LVD Timing Diagram Correction

SPI-3R3 Figure 44 & 45 correction

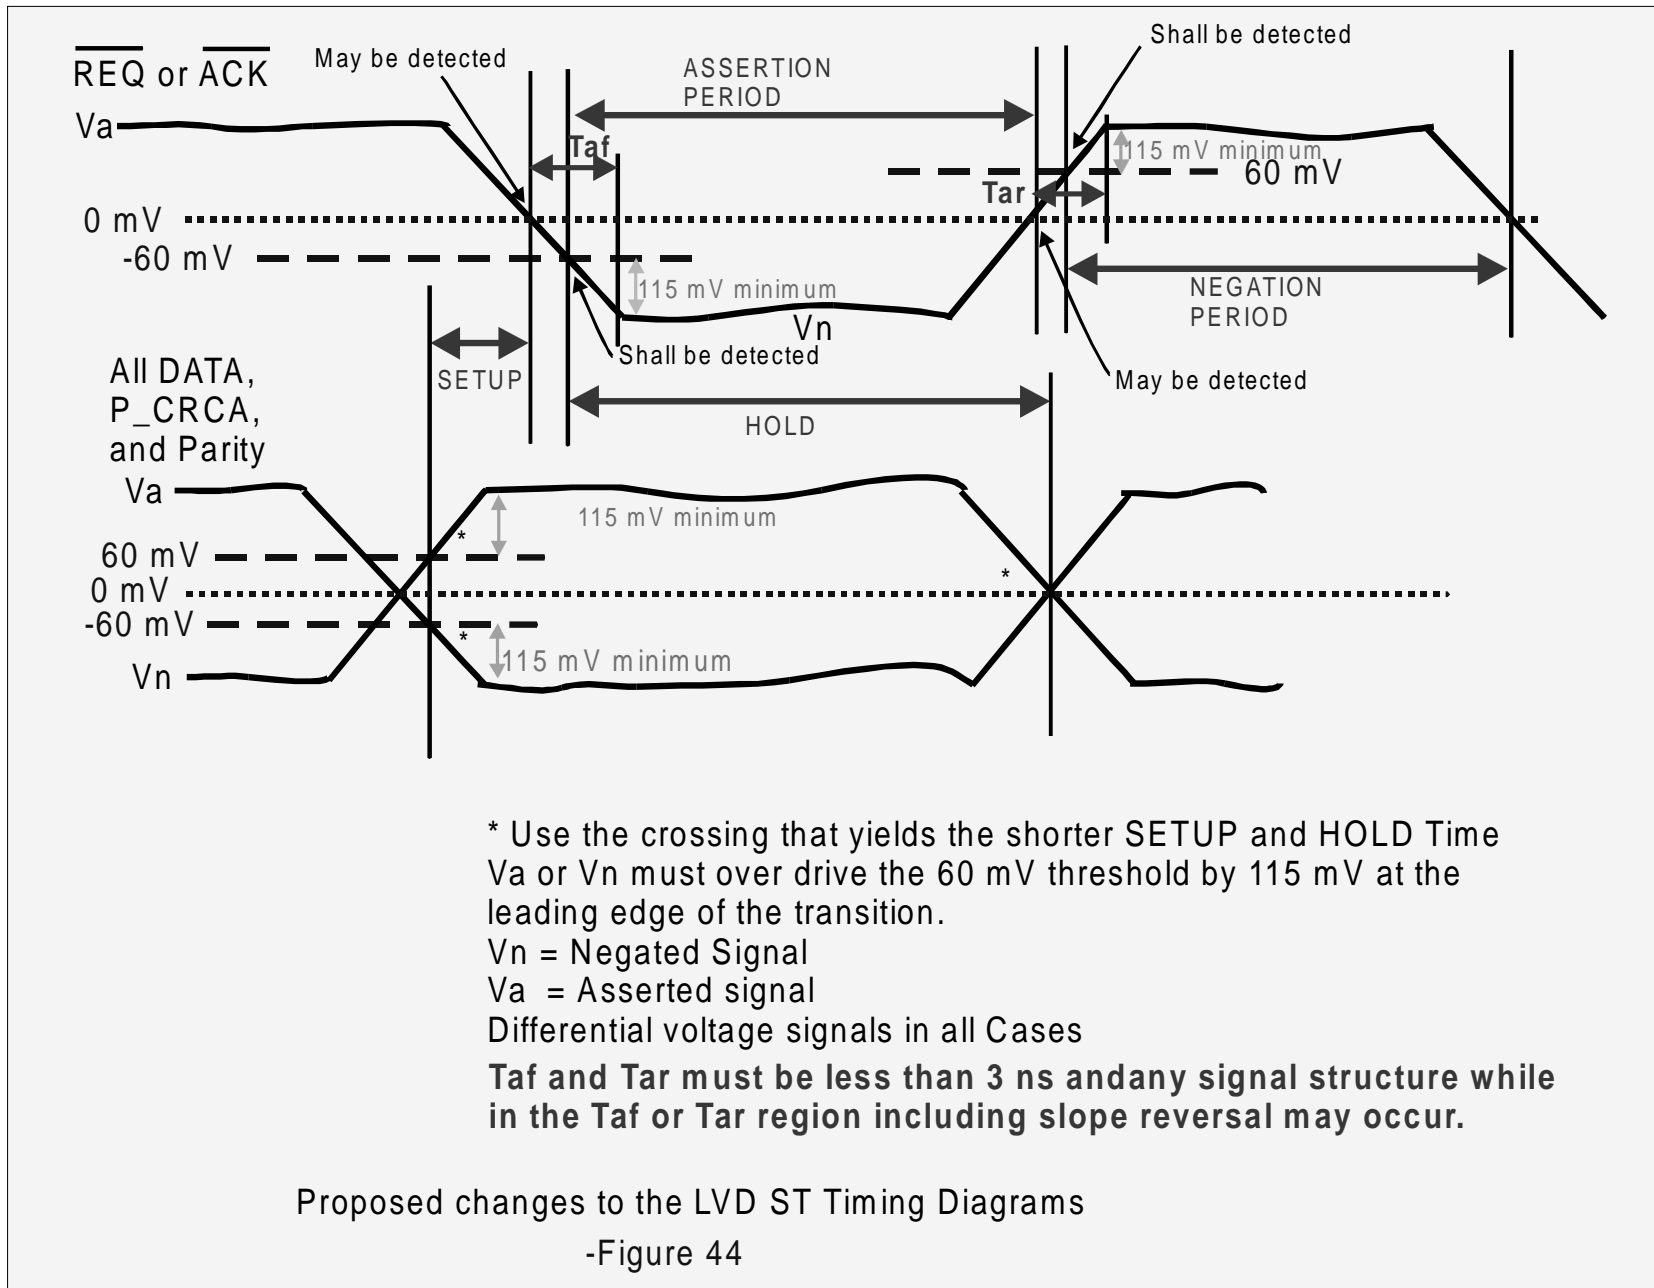
- The receivers require over drive to switch fast enough to not have skew problems.
- The receiver overdrive is not a function of the previous voltage, but a fixed 115 mV over the 60 mV AC threshold.
- AC measurement may switch is not 60 mV, it is 0 mV.
- No Receiver rise - fall time requirements specified

* Use the crossing that yields the shorter SETUP and HOLD Time
 V_a or V_n must over drive the 60 mV threshold by 115 mV at the leading edge of the transition.
 V_n = Negated Signal
 V_a = Asserted Signal
 Differential voltage signals in all Cases
 T_{af} and T_{ar} must be less than 3 ns and any signal structure while in the T_{af} or T_{ar} region including slope reversal may occur.

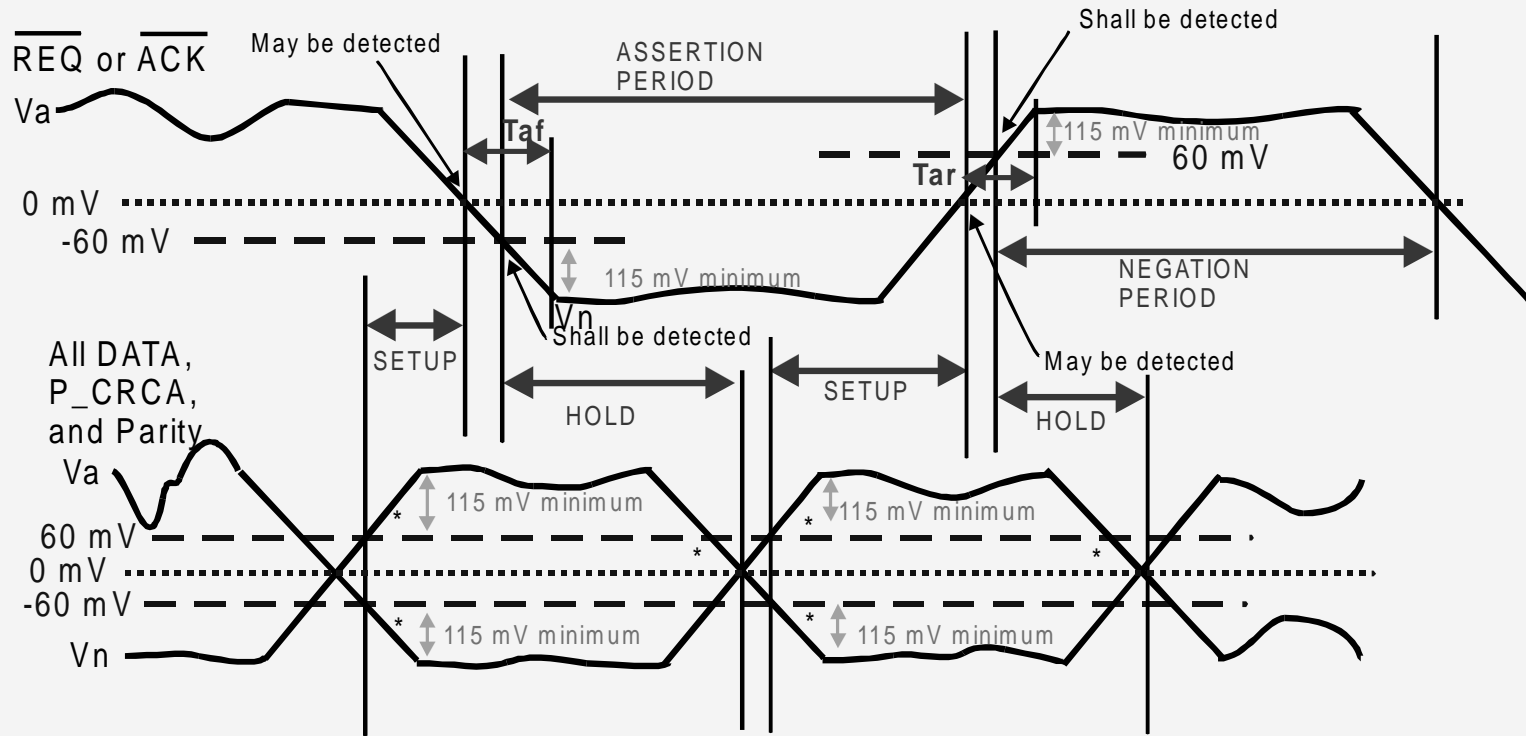
Proposed changes to the LVD DT Timing Diagrams
 -Figure 45
